PERMIT

SEWAGE DISPOSAL SYSTEM

DEPARTMENT OF HEALTH AND MENTAL HYGIENE

SUBDIVISION Talbot's Last Shift LOT 12C ROAD 5213 Talbots Landing

SITE PLAN

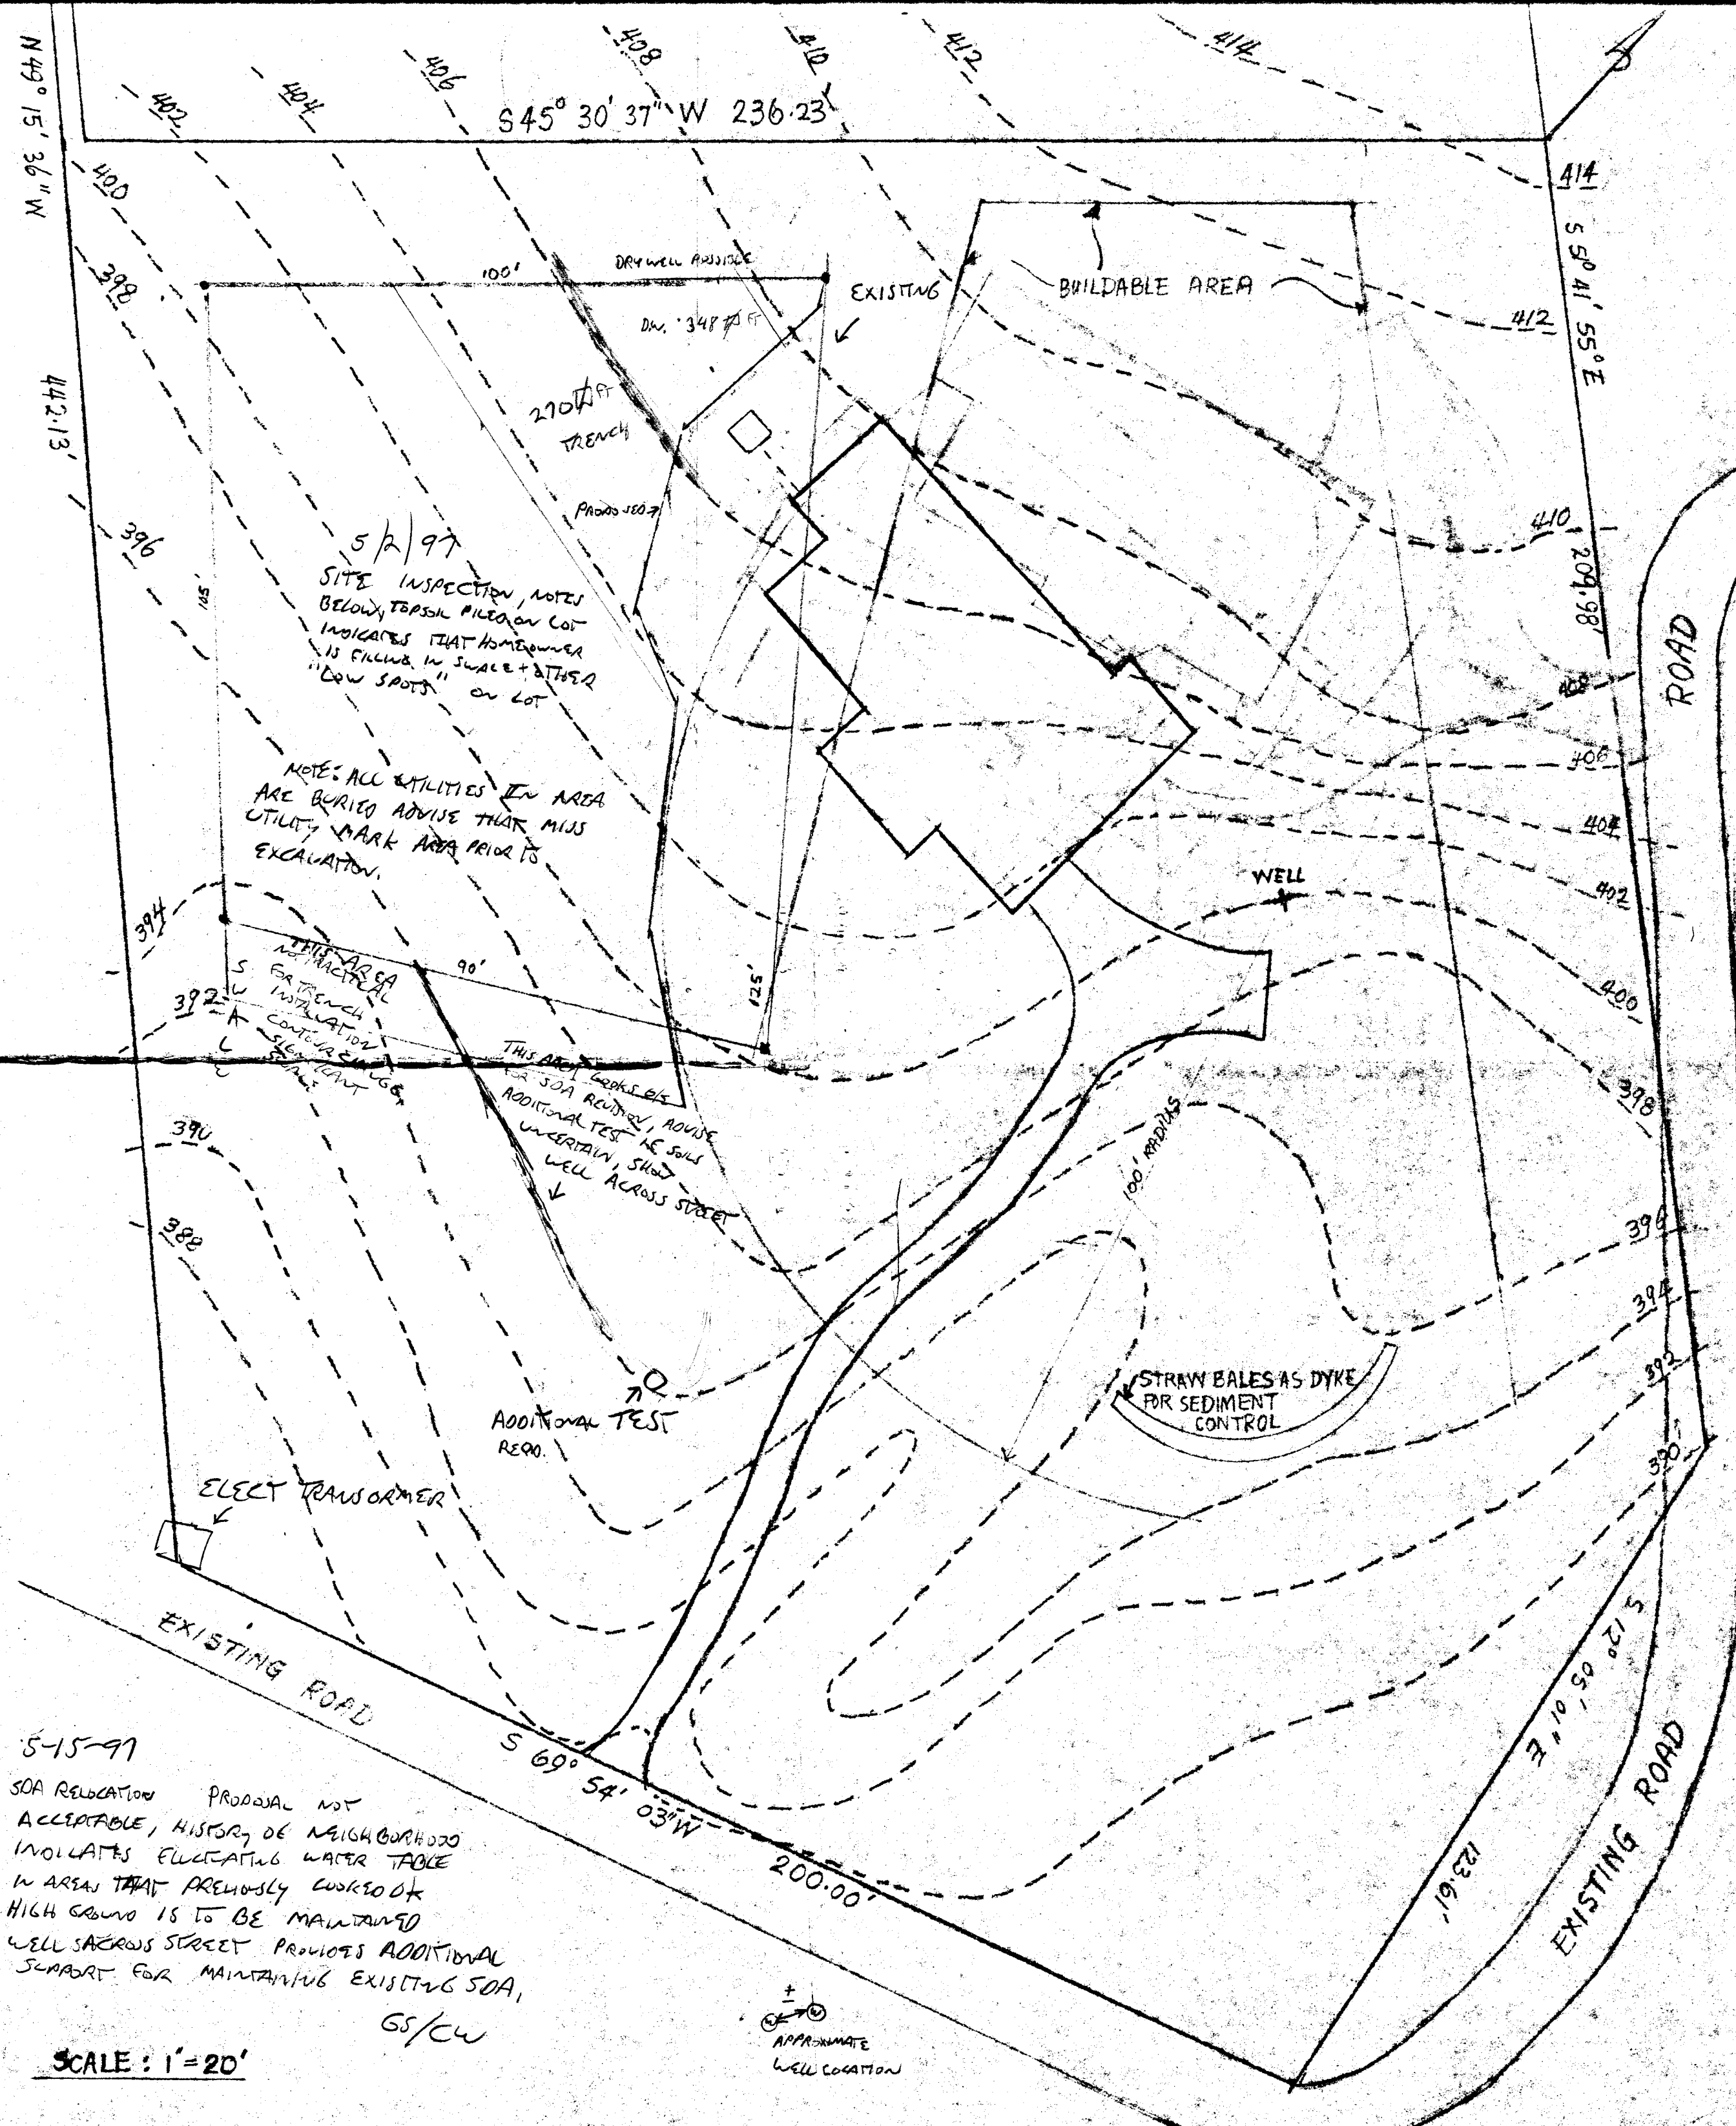
5-15-97
 SOA RELOCATION PROPOSAL NOT
 ACCEPTABLE, HISTORY OF NEIGHBORHOOD
 INVOLVES FLUCTUATING WATER TABLE
 IN AREA THAT PREVIOUSLY LOOKED OK
 HIGH GROUND IS TO BE MAINTAINED
 WELL ACROSS STREET PROVIDES ADDITIONAL
 SUPPORT FOR MAINTAINING EXISTING SOA,
 GS/CW
